Item Name: Crosstube Turning Detail

DART AEROSPACE LTD	Work Order:	93998
Description: Crosstube Assembly (412 High Aft)	Part Number:	D412-664-243
Inspection Dwg: D412-664-243 Rev: E		Page 1 of 2

DRAWING NO. D412-664-243	TITLE CROSSTUBE ASSEMBLY (412 HI AFT)	REV. E	DART AEROSPACE LTD ENGINEERING ORDER		D.E.O. NO. D412-664-243-E-1	SHEET NO. SHEET 1 OF 2	SCALE NTS
DRAWN	CHECKED	MFG. APPR.	APPROVED	DE APPR.			
DATE 11.03.31	DATE 11/03/31	DATE 11.03.31	DATE 11/03/31	DATE 11-03-31

PURPOSE:
REMOVED ABRASION STRIP IN FAVOR OF A THIN LAYER OF PROSEAL 890.

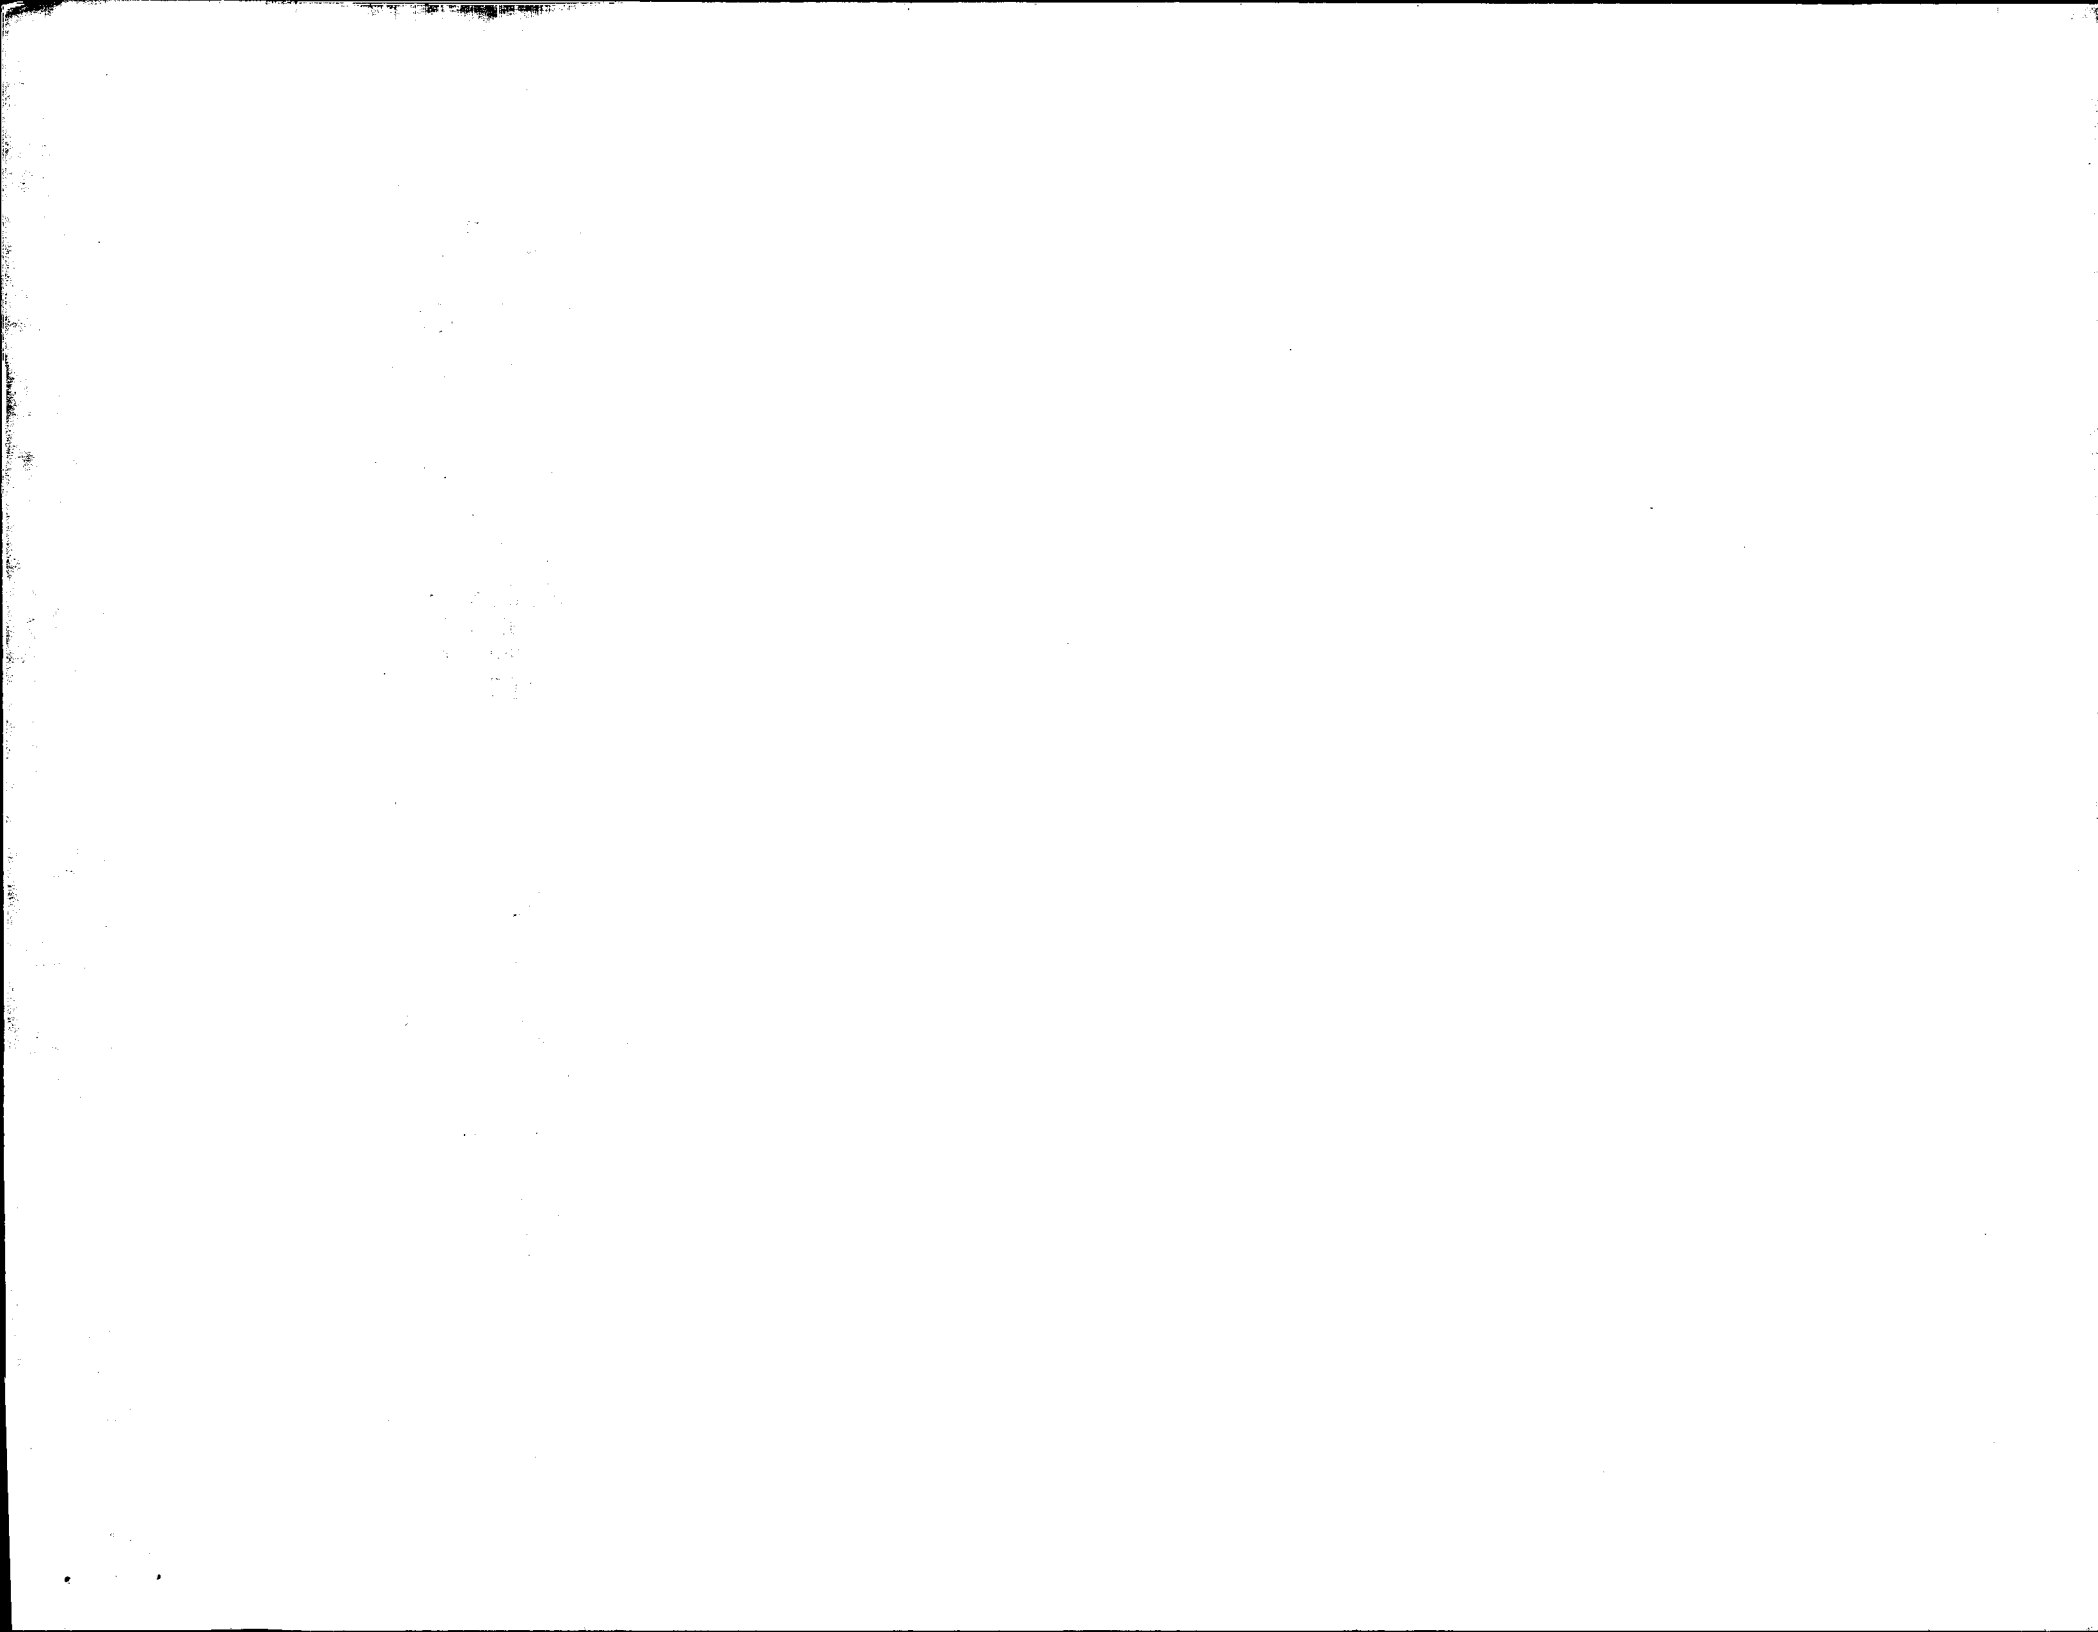
NOTES 2 AND 14, SHEET 1 ARE AMENDED AS FOLLOWS:

- 2) FINISH: CHEMICAL CONVERSION COAT PER DART QSI 005 4.1
PRIME INSIDE AND OUTSIDE PER DART QSI 005 4.2
MASK UNDERSIDE OF CROSSTUBE AS SHOWN (HATCHED AREA)
PAINT OUTSIDE PER DART QSI 005 4.2
AFTER PAINTING, APPLY CLEAR COAT ON HATCHED AREA
- 14) APPLY A THIN COAT OF PROSEAL 890 ON INSIDE CONCAVE SURFACE OF D3189-1
CHAFING SHIELD AND LET CURE PER MANUFACTURER'S INSTRUCTIONS. INSTALL
PROSEALED D3189-1 CHAFING SHIELD ONTO CROSSTUBE BY APPLYING A THIN COAT OF
PROSEAL 890 ONTO CROSSTUBE. BE SURE TO ELIMINATE ANY AIR GAPS.

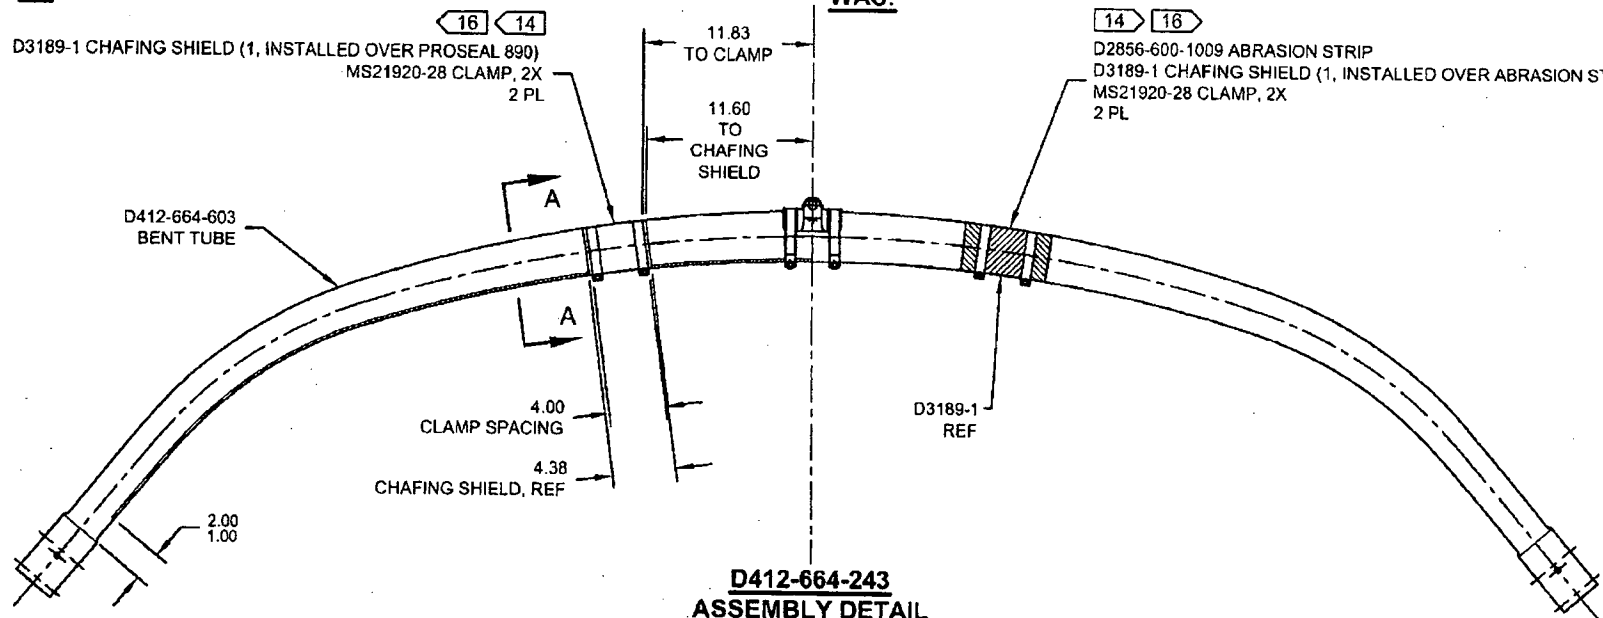
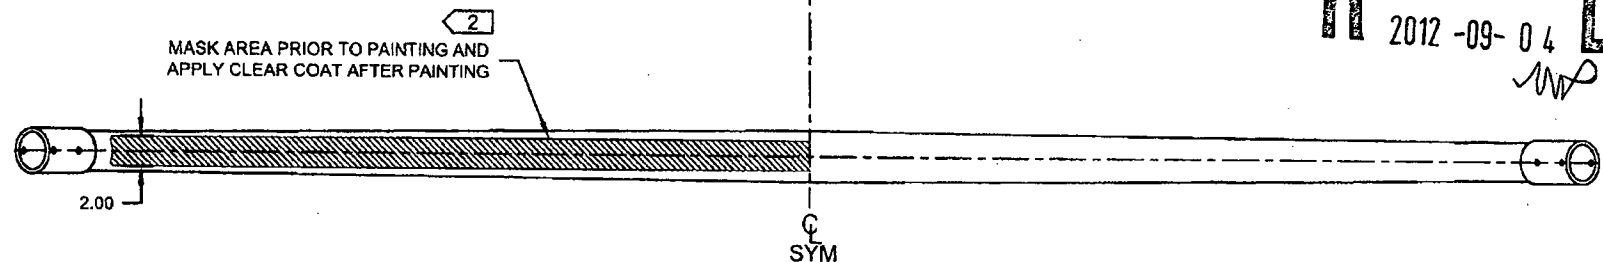
REMOVED ABRASION STRIP IN FAVOR OF A THIN LAYER OF PROSEAL 890. UPDATE INSTALLATION OF CHAFING SHIELDS AND REDUCE TORQUE TO 40-50 IN-LBS. THIS ENGINEERING ORDER SUPERCEDES DEO D412-664-243-E-1.

IS:

D3189-1 CHAFING SHIELD (1, INSTALLED OVER PROSEAL 890)
MS21920-28 CLAMP, 2X
2 PL

**WAS:**

D2856-600-1009 ABRASION STRIP
D3189-1 CHAFING SHIELD (1, INSTALLED OVER ABRASION STRIP)
MS21920-28 CLAMP, 2X
2 PL
